August 2025
Design Development Updates

Upper Brook Street Masterplan (McLaren / Kadans)

UBS-SRA-XX-XX-RP-A-00101

This document has been produced by Sheppard Robson and proposes minor changes to the approved Sci-Tech scheme located in Upper Brook Street, Manchester.

Roof Plan
Consented Plan

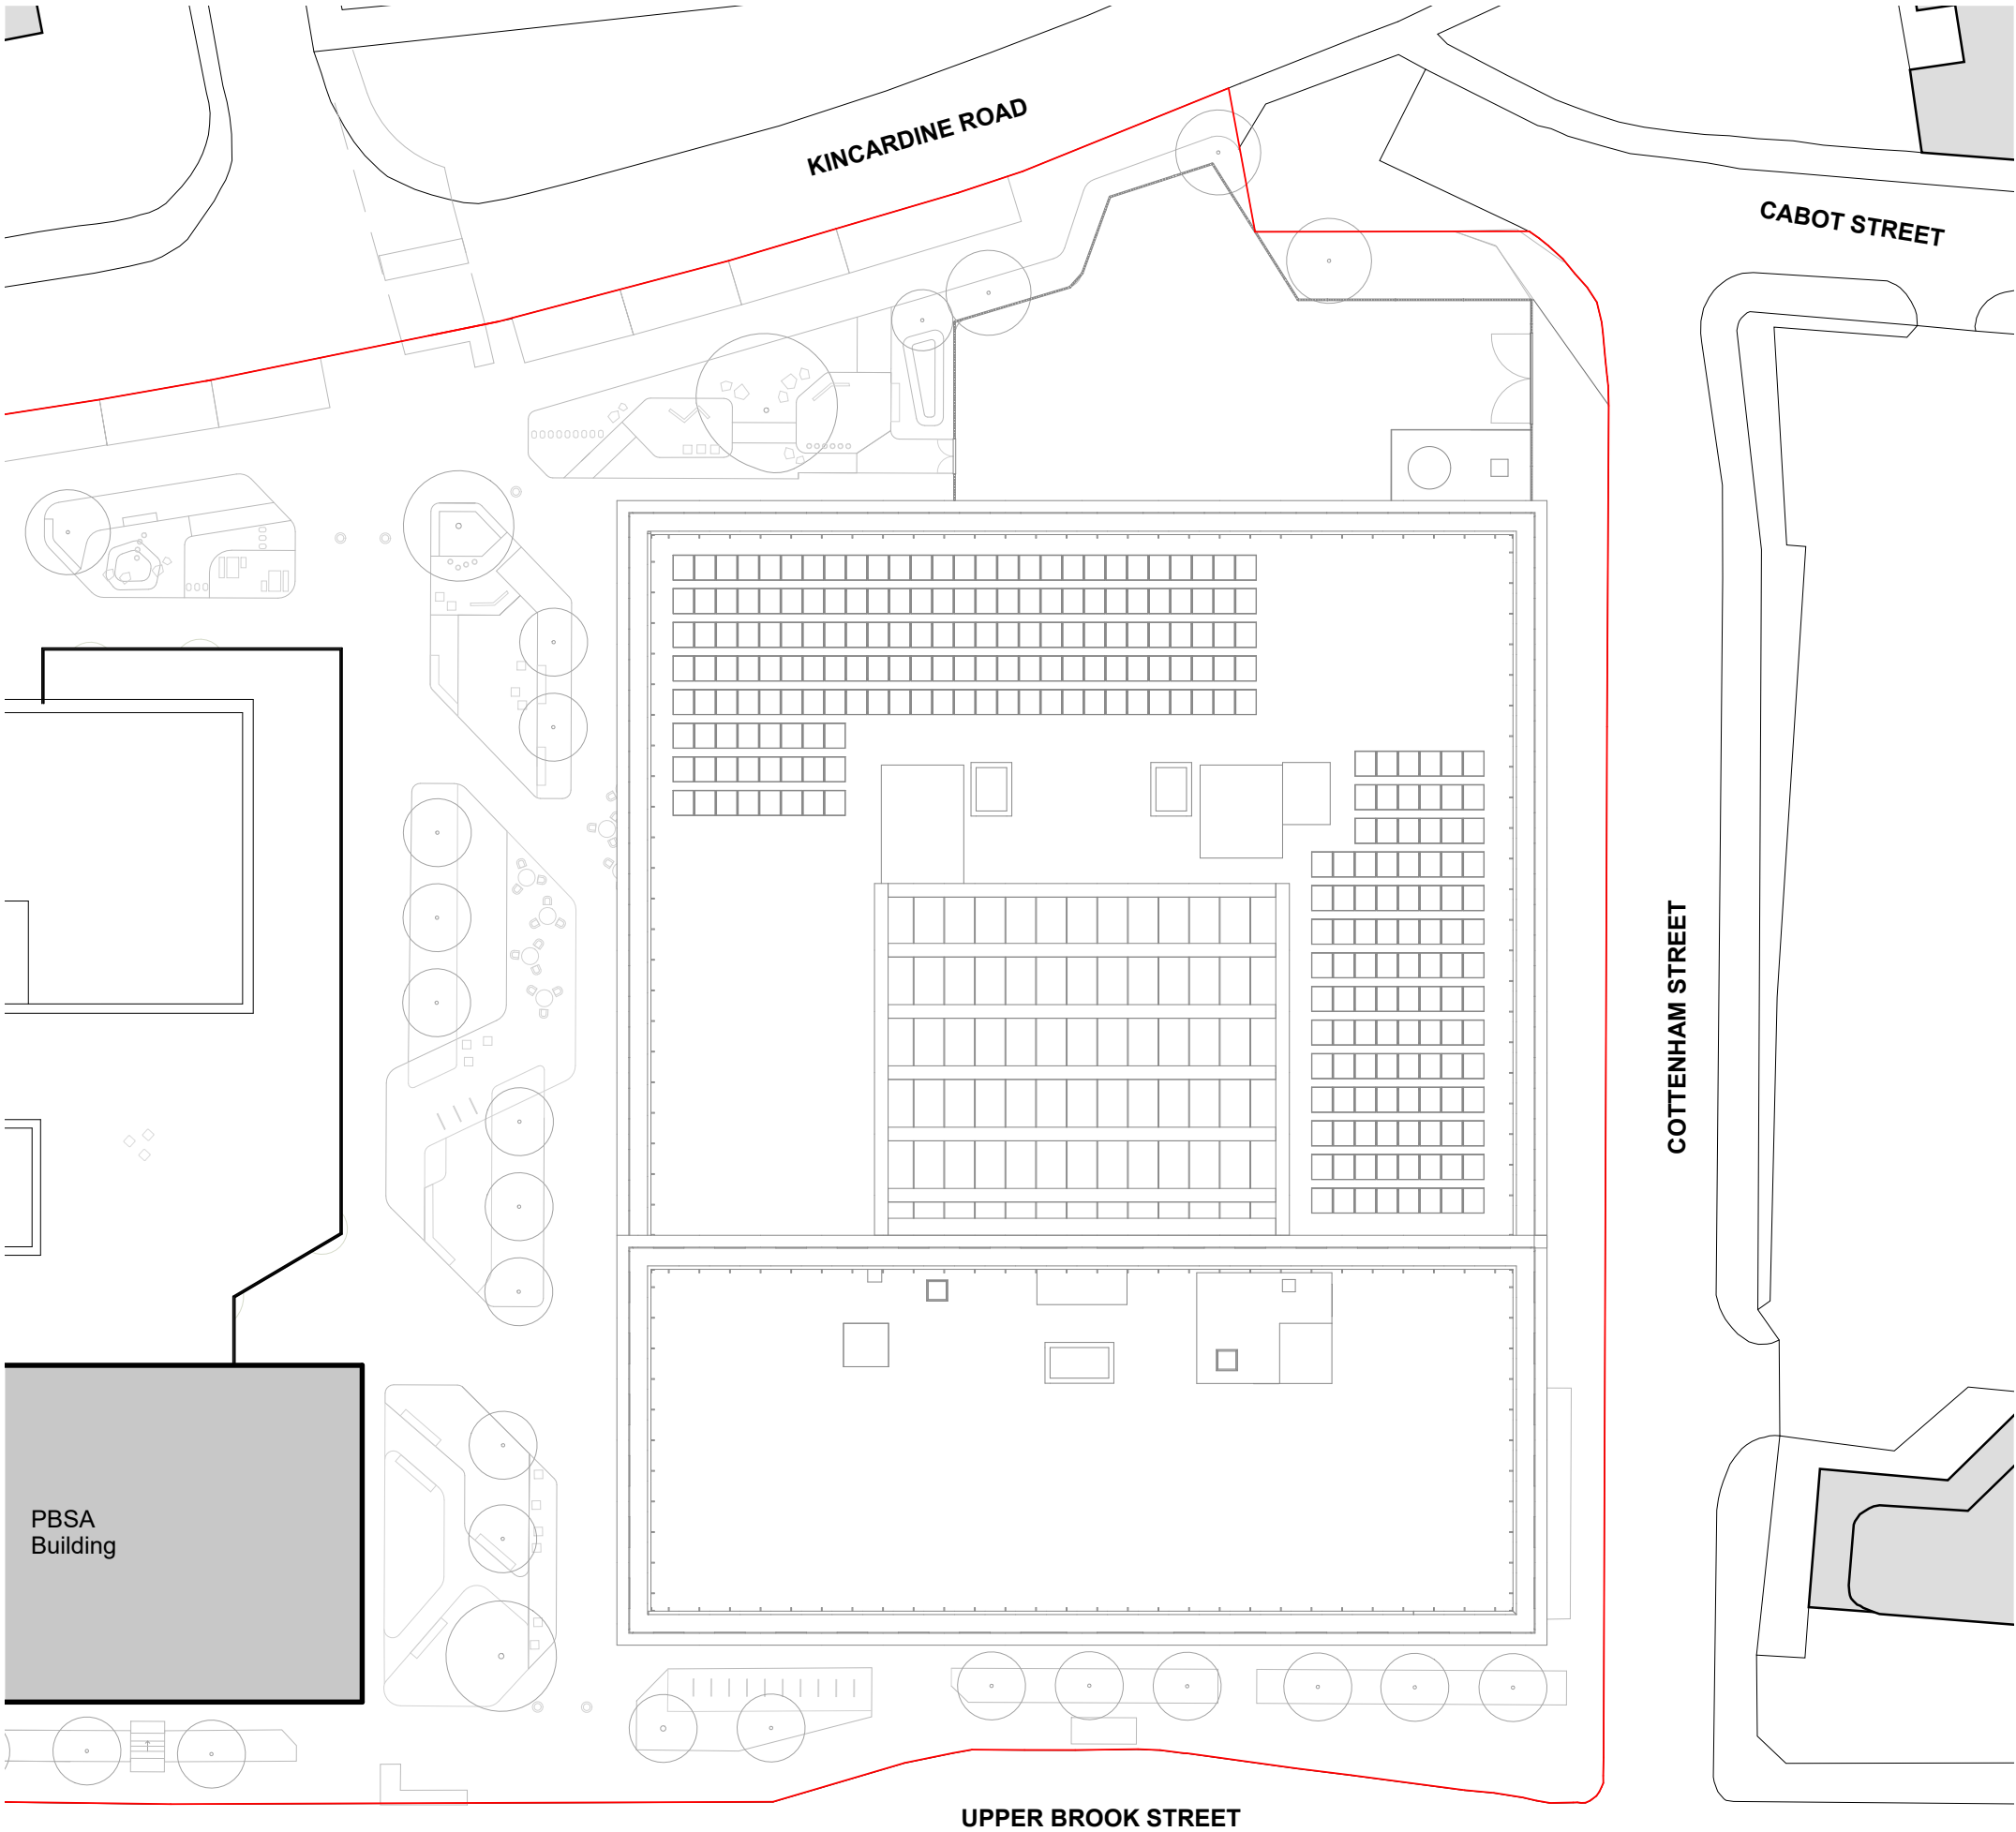
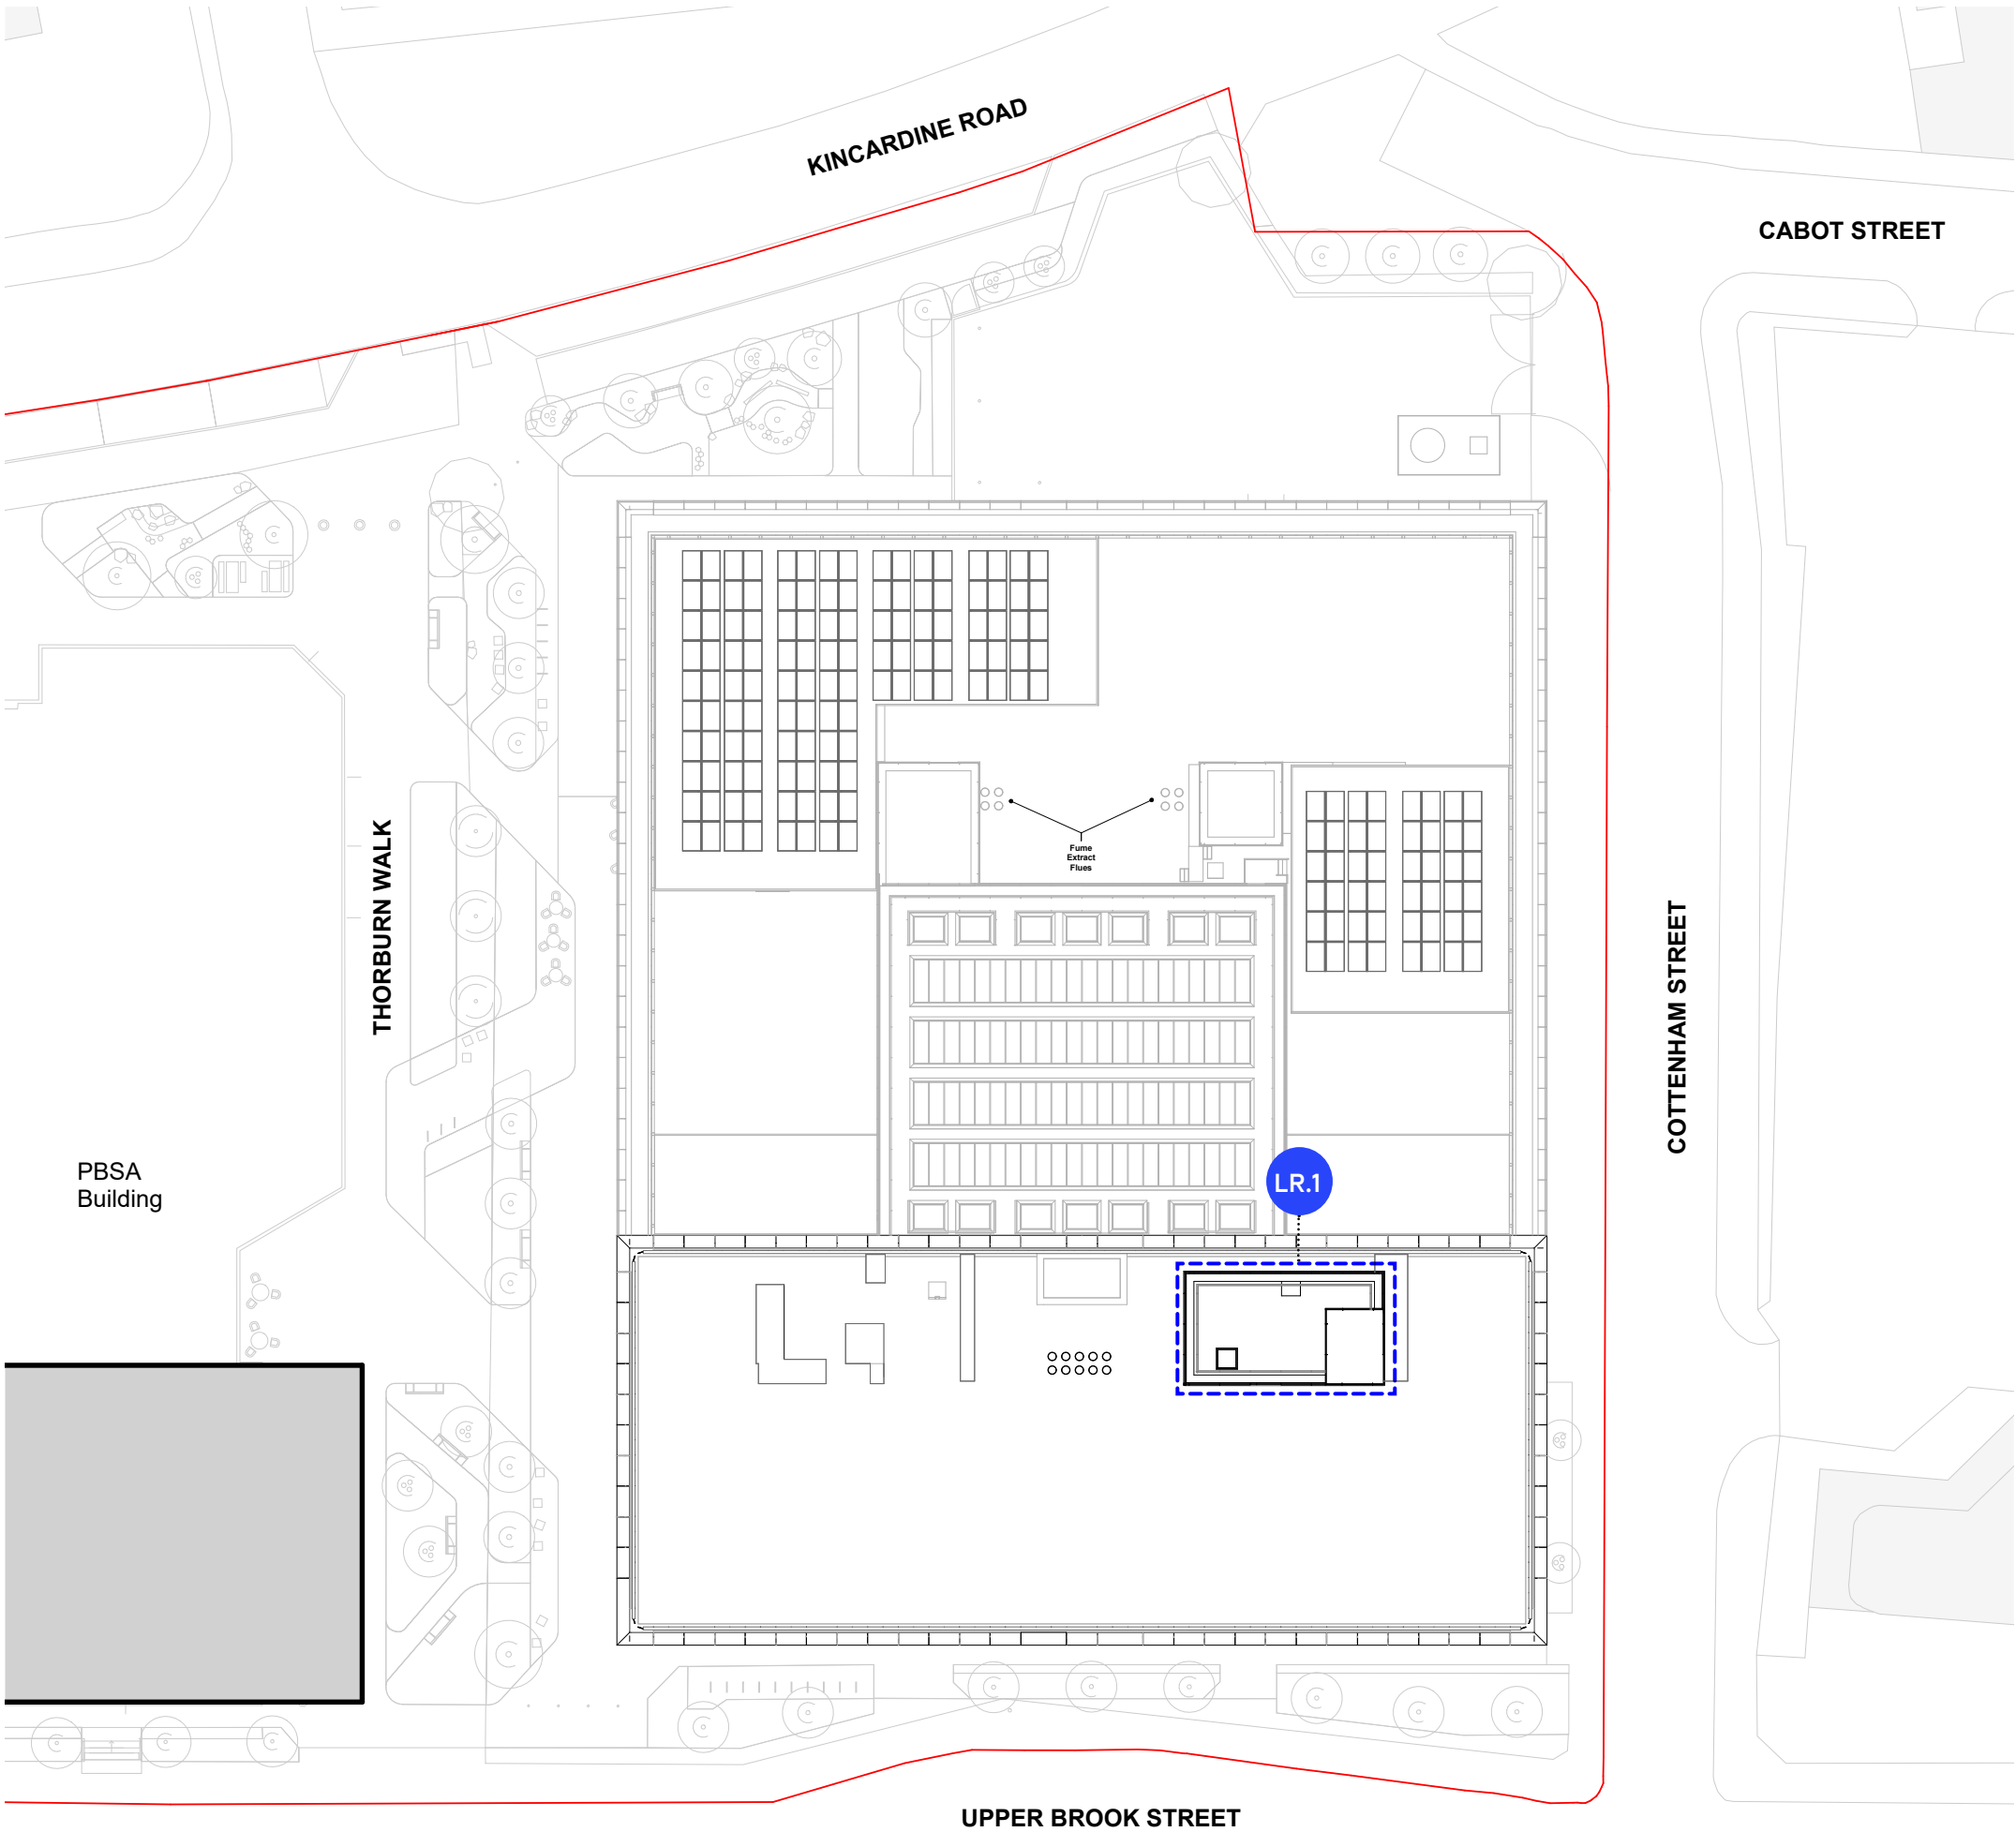
LR.1 Core overrun safety perimeter guardrail added

Change Code	Drawings Affected	Description	Design Development Justification
LR.1	- UBS-SRA-ZZ-ZZ-DR-A-02-104* - UBS-SRA-ST-R1-DR-A-02-509 - UBS-SRA-ZZ-EN-DR-A-02-306 - UBS-SRA-ZZ-ES-DR-A-02-307 - UBS-SRA-ZZ-EE-DR-A-02-308 - UBS-SRA-ZZ-EW-DR-A-02-311 - UBS-SRA-ZZ-SE-DR-A-02-320 - UBS-SRA-ZZ-SE-DR-A-02-321 - UBS-SRA-ZZ-SN-DR-A-02-322	Core overrun roof perimeter safety guardrail added	Core overrun safety perimeter guardrail added to access and maintain ventilation equipment on top of core overrun
